ALTERATION – PHASE 1

**WINDERMERE ELEMENTARY SCHOOL
2 ABBOTT ROAD
ELLINGTON, CT 06029
STATE PROJECT NO. 048-0059 A**

DATE: January 3, 2014

Dwg No: CSK-01

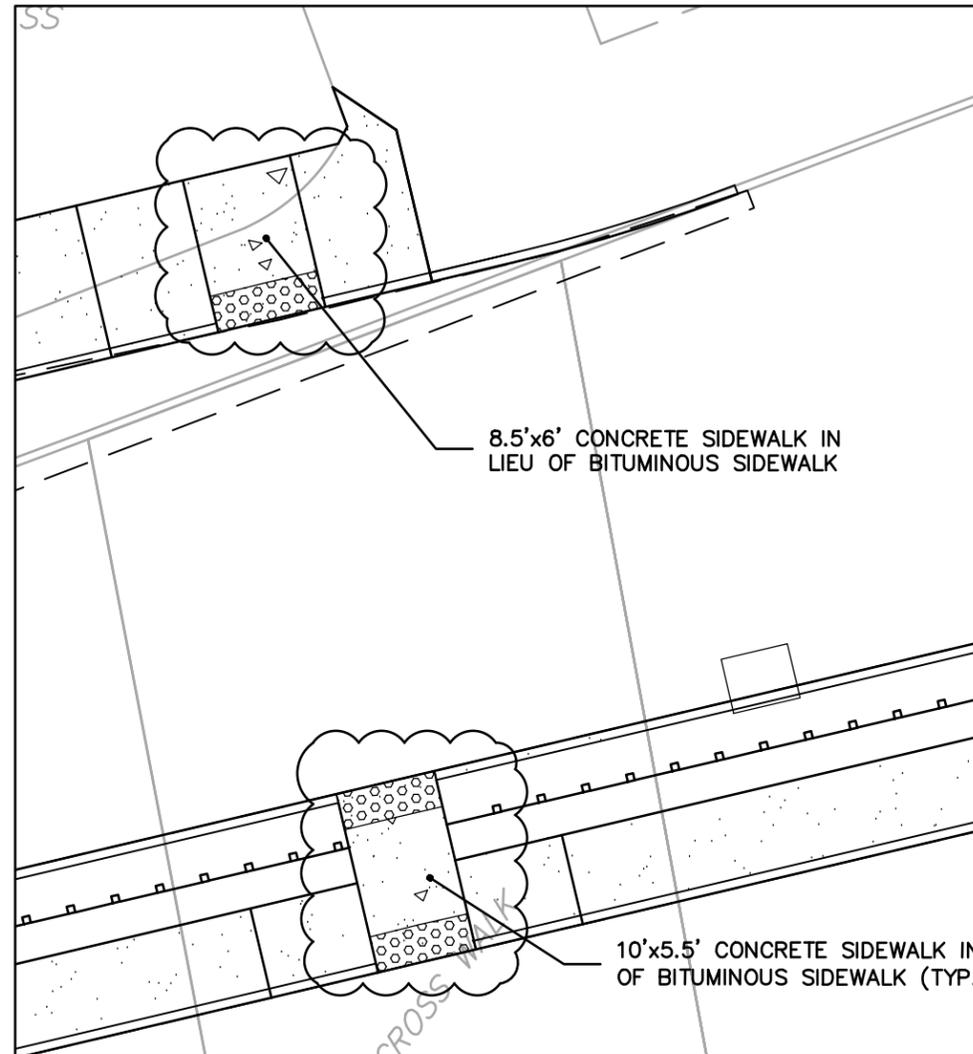
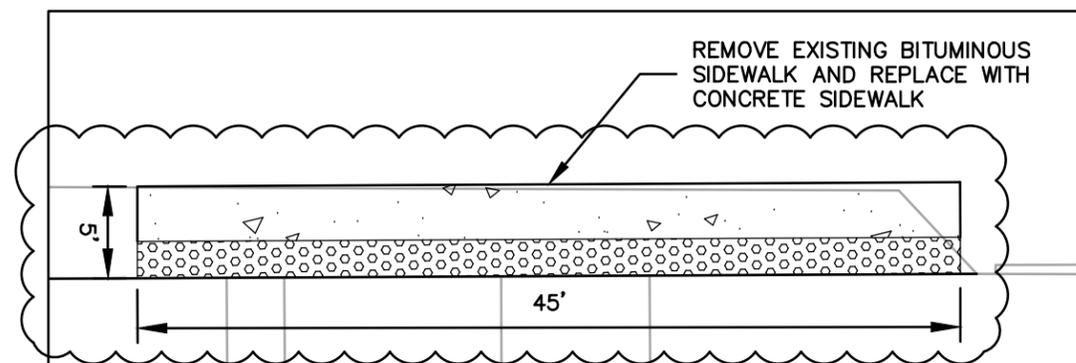
- DRAWING CSK-01, TACTILE WARNING STRIPS IN CONCRETE SIDEWALK has been added and is attached as part of this addendum. This sketch revises information on Drawing C-200.
- DRAWING SKA1, PARTITION TYPE has been added and is attached as part of this addendum. This sketch revises information on Drawing A900.
- DRAWING SKE1, COMPUTER NETWORK RISER has been added and is attached as part of this addendum. This sketch revises information on Drawing E107.

COMPUTER NETWORK SCHEMATIC

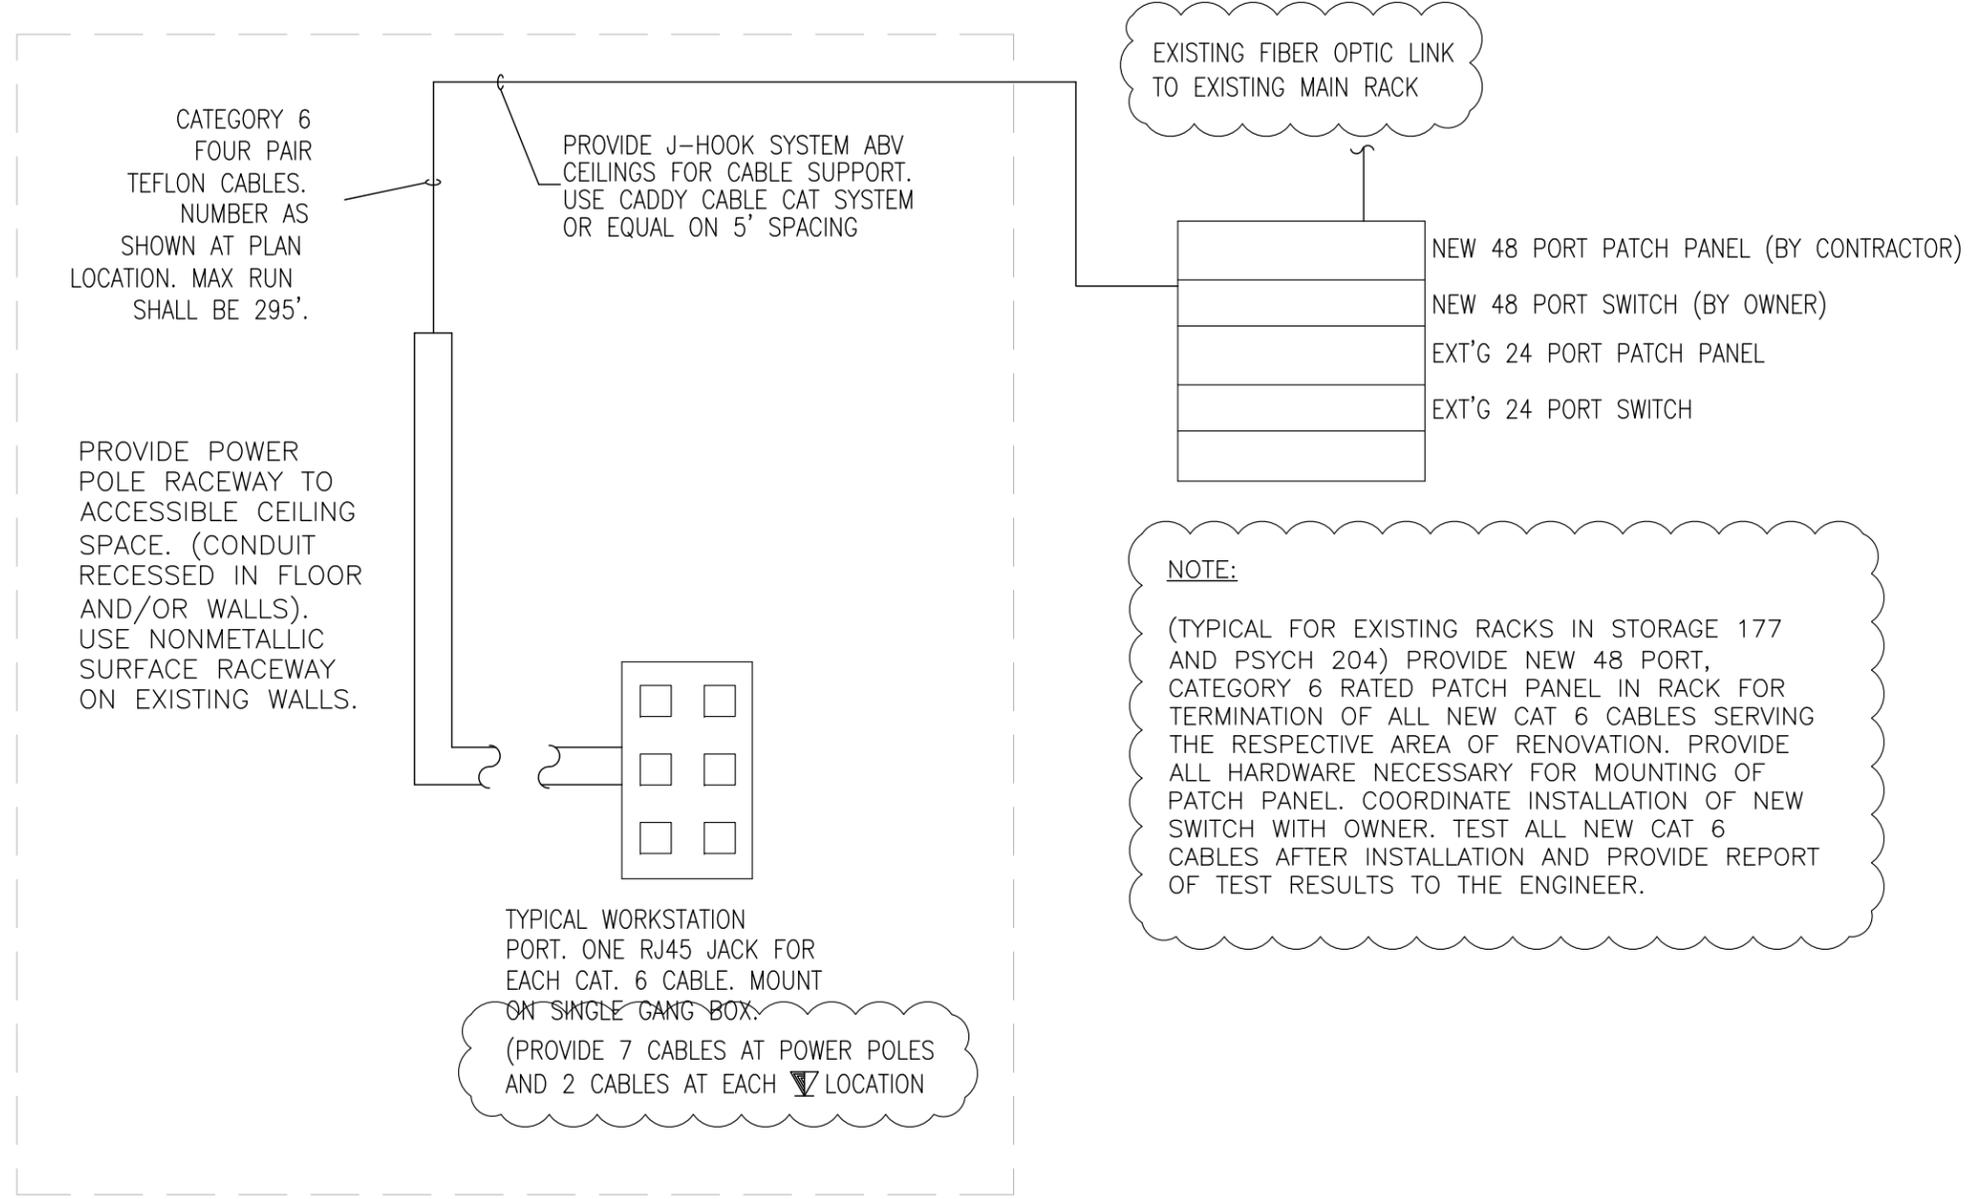
Also what is run between the new data hubs and the main data room? **-Please see sketch in forthcoming addendum.**

Additionally, SKE-1 of Addendum #3 will include additional information for power.
